Masonry flashing must make sure that water travels to the exterior at all locations...We must review all entry points back into the building.

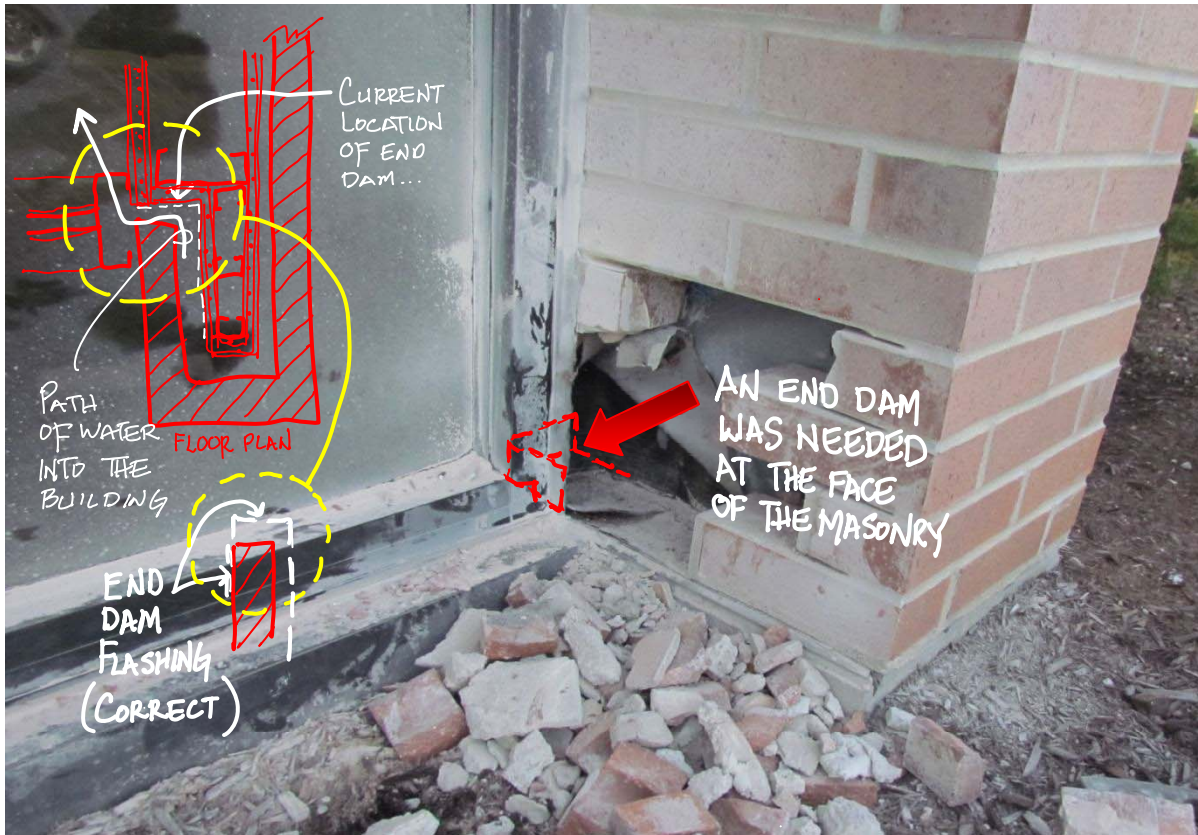
WATER WILL GET INTO THE SYSTEM THROUGH THE MORTAR JOINTS & FAILED SEALANT (OVER TIME)

WATER WAS ABLE TO GET IN-BETWEEN THE WINDOW END DAM & THE MASONRY

The End dam was located only at the end of the masonry run...and not on the side of the window unit.

This is a common mistake that is frequently overlooked.
